SUBJECT: DUANE ARNOLD ENERGY CENTER - STAFF ASSESSMENT OF INFORMATION PROVIDED PURSUANT TO TITLE 10 OF THE *CODE OF FEDERAL REGULATIONS* PART 50, SECTION 50.54(f), SEISMIC HAZARD REEVALUATIONS FOR RECOMMENDATION 2.1 OF THE NEAR-TERM TASK FORCE REVIEW OF INSIGHTS FROM THE FUKUSHIMA DAI-ICHI ACCIDENT (TAC NO. MF3783)

STAFF ASSESSMENT BY THE OFFICE OF NUCLEAR REACTOR REGULATION

RELATED TO SEISMIC HAZARD AND SCREENING REPORT

DUANE ARNOLD ENERGY CENTER

the DAEC Site

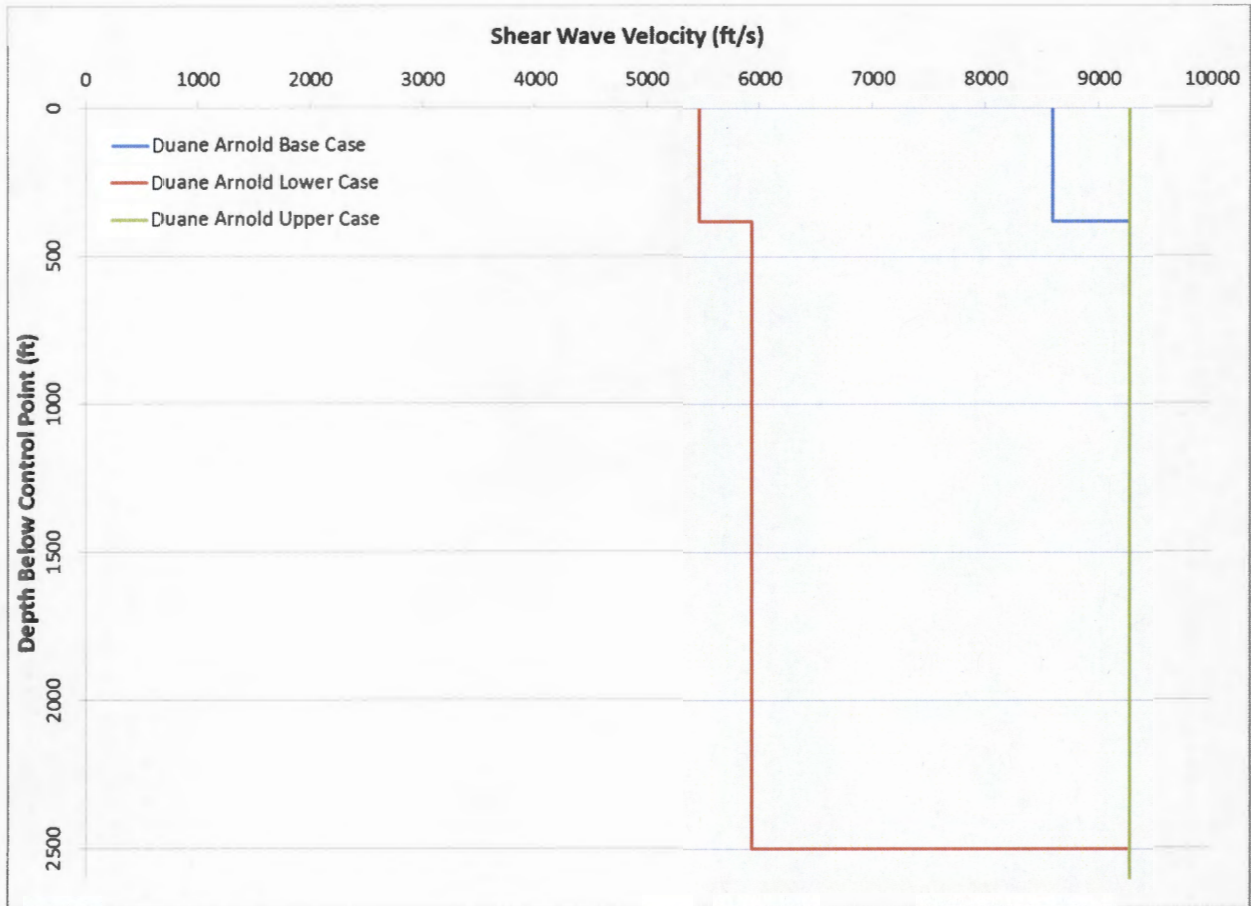
The licensee assumed the depth from the SSE to reference rock is either 380 ft. (116 m) at the top of the Ordovician, or 2,500 ft. (762 m). To capture the uncertainty in the shear wave velocity beneath the site, the licensee developed three base-case profiles using a scale factor of 1.57. The licensee used this scale factor and the estimated shear wave velocities to develop the base-case profiles for the DAEC site. For the best estimate base-case profile, the licensee assumed that reference rock conditions occur at a depth of 380 ft. (116 m) below the SSE, at the bottom of the upper limestone unit. For the lower range profile, the licensee assumed that reference rock conditions occur at a depth of 2,500 ft. (762 m), at the base of the sedimentary section. For the upper base-case, the licensee assumed that reference rock conditions occur at the depth of the SSE control point. Figure 3.3-1 of this assessment shows the licensee's three shear-wave velocity base case profiles.

To confirm the licensee's site response analysis, the NRC staff performed site response calculations for the DAEC site. Based on the limited subsurface data at the site and because the licensee followed the guidance in the SPID for sites with limited data, the NRC staff used the licensee's three base case shear wave velocity profiles for its confirmatory analysis. Figure 3.3- 1 of this assessment shows the licensee's and staff's three shear-wave velocity base case profiles.

Figure 3.3- 1 Plot Comparing the Staff's and the Licensee's Median Amplification Functions and Uncertainties for the DAEC site.

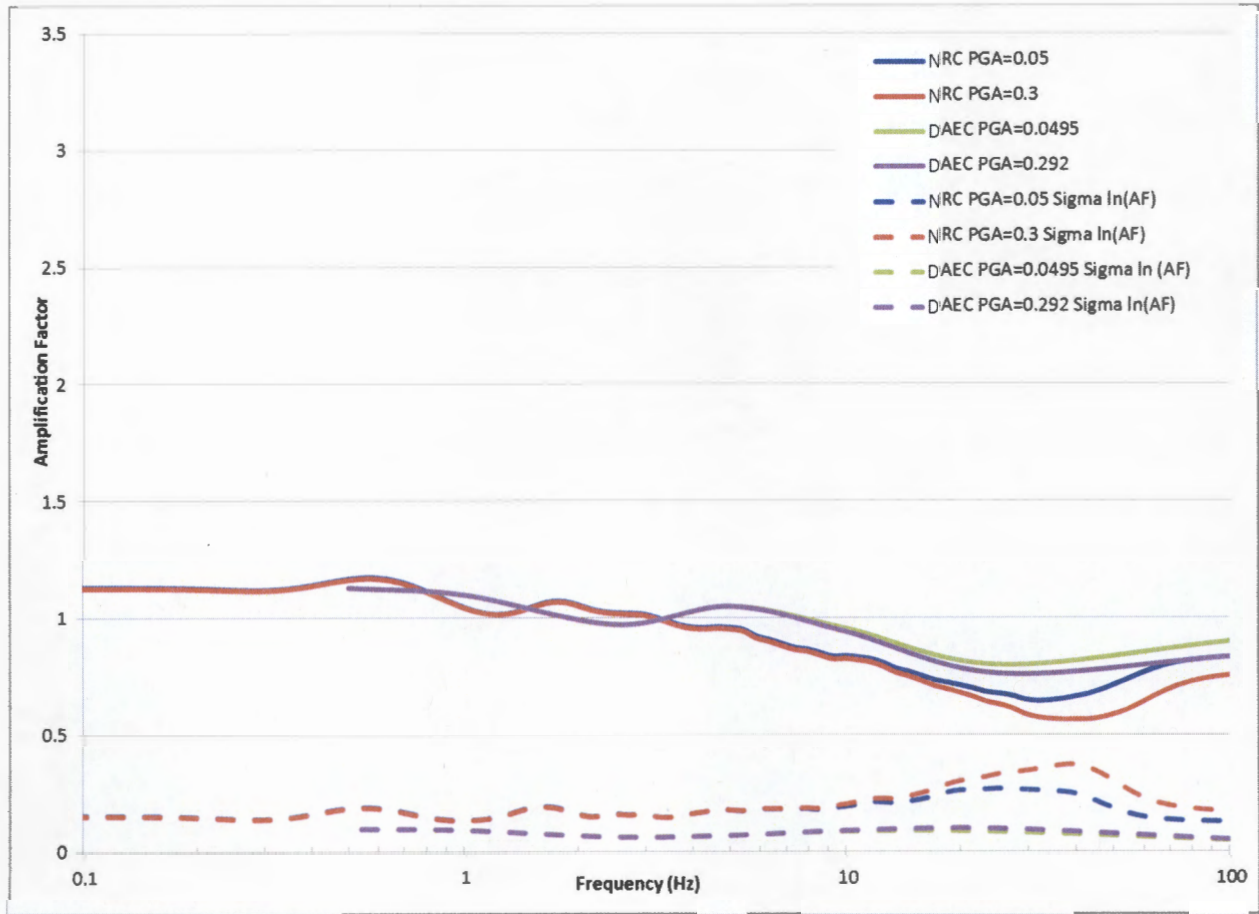
Figure 3.3-2 of this assessment shows a comparison of the NRC staff's and licensee's median site amplification factors and uncertainties (± 1 standard deviation) for two of the eleven input loading levels. As expected, due to similar site response analyses, the staff's median site amplification factors are very close to the licensee's. Based on the staff's confirmatory calculations of amplification factors, the NRC staff concludes that the licensee's evaluation for the DAEC site adequately captures the site amplification occurring as a result of bedrock ground motions travelling upward through the soil/rock column to the control point elevation.

Figure 3.3-2 Plot Comparing the Staff's and the Licensee's Mean Control Point Hazard Curves at a Variety of Frequencies for the DAEC site

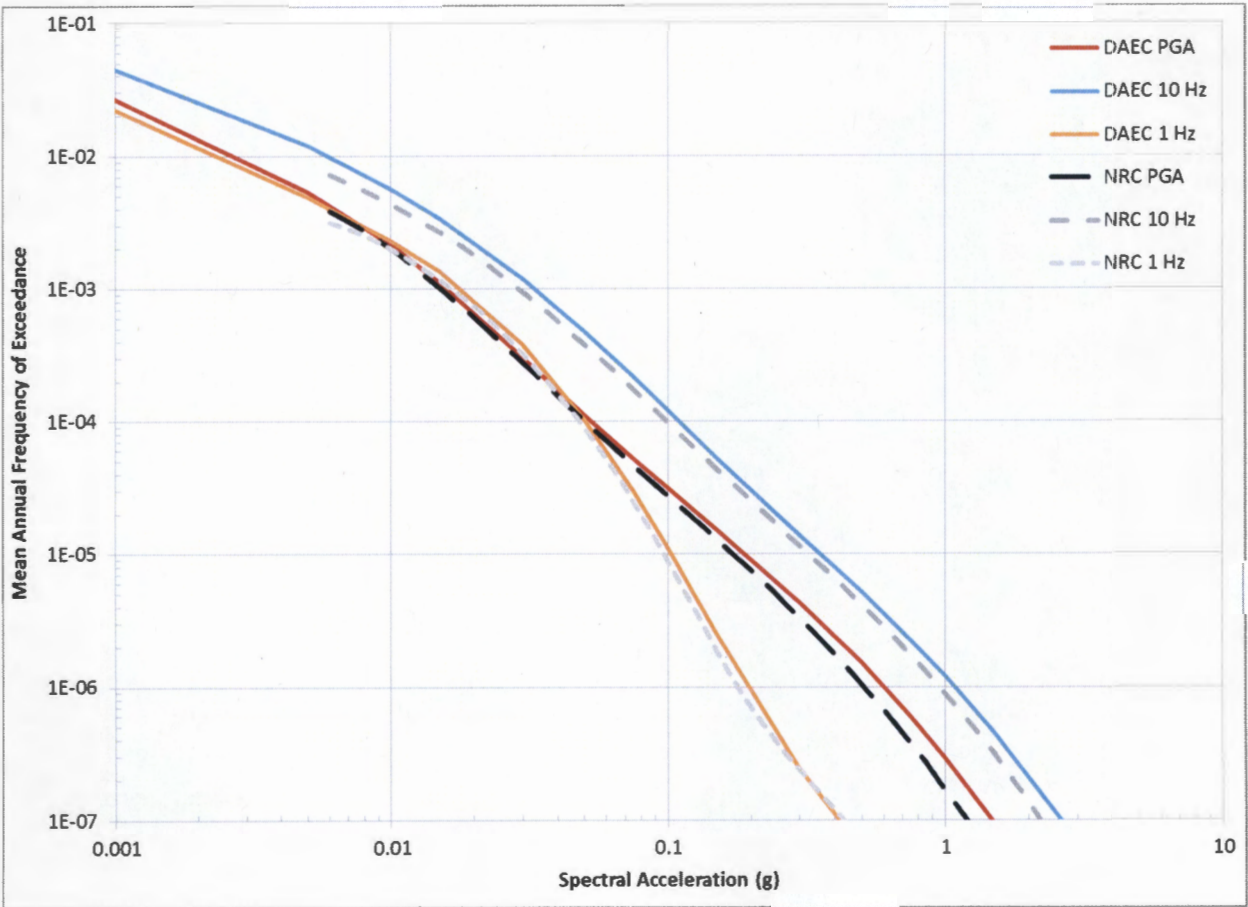
Figure 3.3-3 of this assessment shows that the licensee's and NRC staff's control point hazard curves are also very similar. Minor differences are due primarily to the licensee's use of higher low strain damping (three percent) than the damping value (one percent) used by the NRC staff for the rock. Appendix B of the SPID provides guidance for performing site response analyses, including capturing the uncertainty for sites with less subsurface data; however, the guidance is neither entirely prescriptive nor comprehensive. As such, various approaches in performing site response analyses, including the modeling of uncertainty, are acceptable for this application.

Figure 3.4-1 Comparison of the Staff's GMRS with Licensee's GMRS and the SSE for the DAEC site

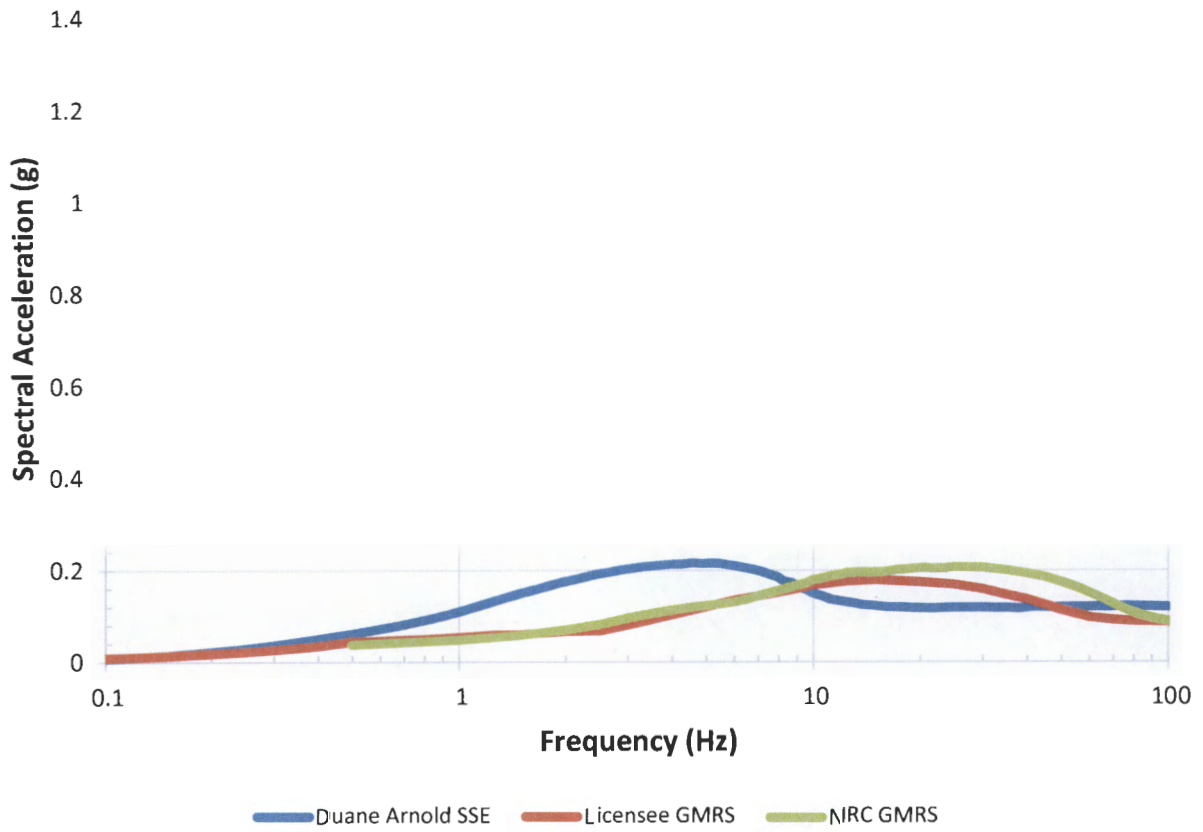
The NRC staff independently calculated the 10^{-4} and 10^{-5} UHRS using the results of its confirmatory PSHA and site response analysis, as described in Sections 3.2 and 3.3 of this staff assessment, respectively. Figure 3.4-1 of this assessment shows a comparison of the GMRS determined by the licensee to that determined by the NRC staff.

As shown in Figure 3.4-1, the licensee's GMRS shape is very similar to that calculated by the NRC staff. At higher frequencies, the staff's confirmatory GMRS is slightly higher than the licensee's. These differences in GMRS are the result of differences in the site response analyses performed by the licensee and NRC staff as discussed in Section 3.3 above.
